<b>Wulfsberg Electronics</b> <i>A Chelton Group Company</i>		
<b>APPROVALS</b>				<b>DATE</b>
DRAWN	Robert DuRall	8/7/07		<b>TITLE:</b> <b>SERVICE BULLETIN WSB IDU-III-23</b> <b>(ANNUNCIATED SWITCH REPLACEMENT)</b>
CHECKED	Leslie Evans	8/7/07		
PRODUCT MANAGER	----	---		
ENGINEER	Dean R. Boston	8/7/07		<b>SIZE</b> <b>A</b>
ISSUED	Leslie Evans	8/8/07		
		<b>CAGE CODE</b>	<b>DWG NO.</b>	<b>REV</b>
		<b>1B7G3</b>	<b>150-045079</b>	<b>B</b>
<b>Typed signatures indicate approval. Handwritten signature approval of this document is on file at Wulfsberg Electronics, Prescott, Arizona.</b>		<b>SCALE: NONE</b>		<b>DO NOT SCALE DRAWING</b>

## SERVICE BULLETIN

**EQUIPMENT:** IDU-III

**BULLETIN NUMBER:** WSB IDU-III-23 Revision B

**Figure 3** TAWS INHIBIT Switch Wiring

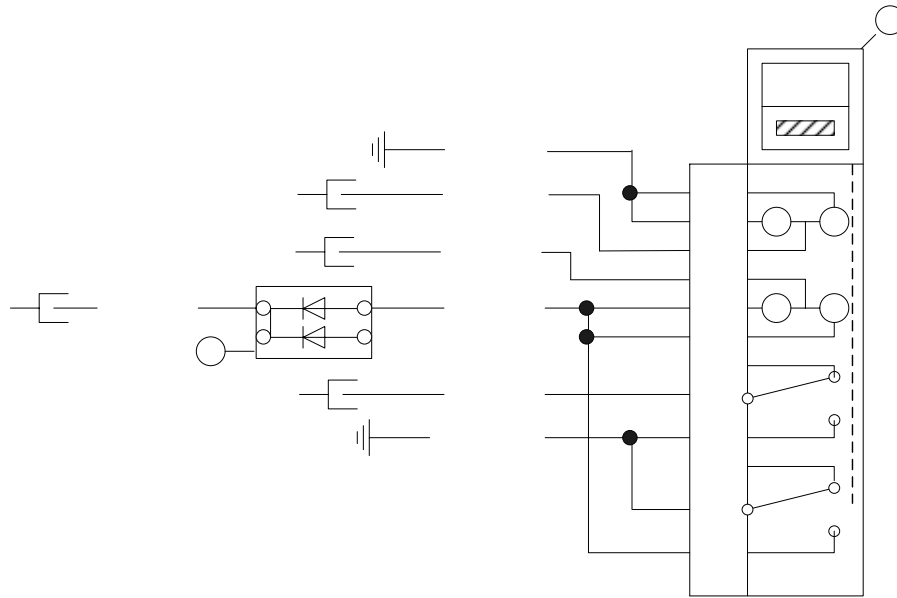
2. If the existing switch is a toggle switch with placard, go to Step 9.
3. Remove the existing switch and de-pin. Ensure all wires are properly marked for reuse.
4. Determine if the existing pins are acceptable and re-pin as required for the new switch.
5. Install the new TAWS INHIBIT (Item 1) switch in the existing hole.
6. Wire the switch using the Aerospace Optics Connector Kit (Item 3) and existing aircraft wires as shown in Figure 3.

12. Install new TAWS INHIBIT switch (Item 1) in the hole.
13. Using the Aerospace Optics Connector Kit (Item 3) and existing aircraft wires; add new wires and a Diode Module (Item 4) to complete the installation as shown in Figure 3.
14. Connect the lighting power to the aircraft’s existing dimmer system.
15. Connect the Press-To-Test (PTT) wire to the aircrafts’ existing PTT circuit.
16. Secure the wiring as required.
17. Go to “LOW ALTITUDE SWITCH INSTALLATION” section.

**NOTE:** +28VDC Lighting Bus is a non-dimmable bus protected by a circuit breaker of 5 Amps maximum.

**Figure 4** Typical Annunciated Switch Cutout

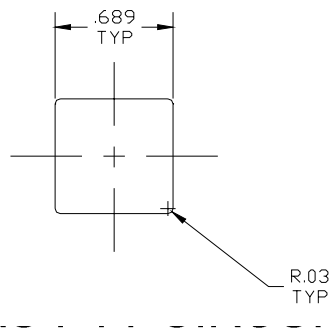
7. Secure the wiring as required.
8. Go to “LOW ALTITUDE SWITCH INSTALLATION” section.
9. Remove the TAWS INHIBIT toggle switch.
10. Use the existing ground wire and discrete wire for the new switch.
11. Cut a new hole using Figure 4 as guidance.

2. Cut a new hole using Figure 4 as guidance.
3. Install the new LOW ALTITUDE switch (Item 2) in the hole.
4. Using the Aerospace Optics Connector Kit (Item 3), a Diode Module (Item 4) and new wires, modify the aircraft to complete the installation as shown in Figure 5.
5. Connect the lighting power using the aircrafts' existing dimmer system.
6. Connect the Press-To-Test (PTT) wire to the aircrafts' existing PTT circuit.
7. Add a wire to the EFIS Interconnect Cable as shown in Figure 6.
